## 2-1. Site Location and Layout (Section 2.1)

## 2-2. Meteorology (Section 2.5)

Energy Metals Corporation  
Responses to NRC Request For Additional Information  
Moore Ranch Uranium Project Source Material License Application

FIGURE 2.2a-1

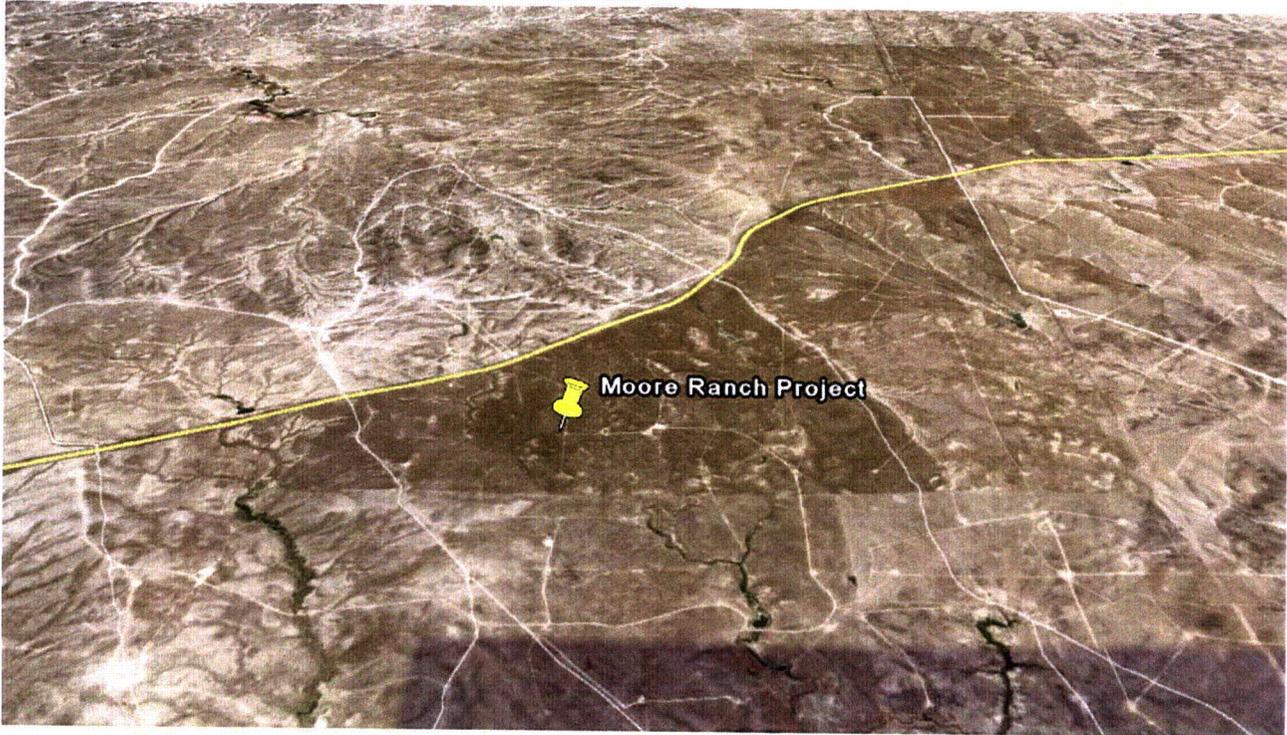
- a. The applicant indicated that no onsite meteorological data was collected at the Moore Ranch site but instead, used meteorological data collected from Antelope Coal (ACC) and Glenrock Coal (GCC) to represent the Moore Ranch site. However, the applicant has not discussed its basis to assume that the data can be used to represent the Moore Ranch site without any data from the Moore Ranch site. Therefore, provide the justification to use the data from these two sites (ACC and GCC), without onsite meteorological data, to represent the Moore Ranch site.

The proposed project is situated in east-central Wyoming. It is encompassed by the area between the North Platte valley and the Montana border, generally referred to as the Powder River Basin (PRB). Due to uniformities in geography and climate, the PRB is treated by state and federal regulators as a single air quality control area.

As stated in the conclusion of the Climatology Report, the Antelope Mine (ACC) meteorology most nearly represents that of the Moore Ranch project site, and is therefore proposed as the source of meteorological data to be substituted for on-site monitoring. Data from the Glenrock Mine (GCC) was intended only to supplement ACC and to support the general conclusions made regarding local meteorology. To illustrate the similarities between Moore Ranch and ACC, several images from Google Earth are presented below. Figure 2.2a-1 shows an aerial view of the Moore Ranch area, and Figure 2.2a-2 shows a similar view of the ACC site (with meteorological station pinpointed). The ACC site has similar topographic features (Figure 2.2a-3) and is about 25 miles from the project site (Figure 2.2a-4). Both sites are characterized by mildly rolling hills covered with grass and sparse shrubs. The nearest mountain ranges are:

Due to these large distances, neither the ACC site nor the Moore Ranch site experiences significant wind channeling or shielding from any of the three mountain ranges. Also, there are no major bodies of water affecting the meteorology of these two sites. The ACC site is several hundred feet lower in elevation than Moore Ranch. Both, however, are situated on the southeasterly side of the hydrologic divide with a similar vertical relationship to the divide.
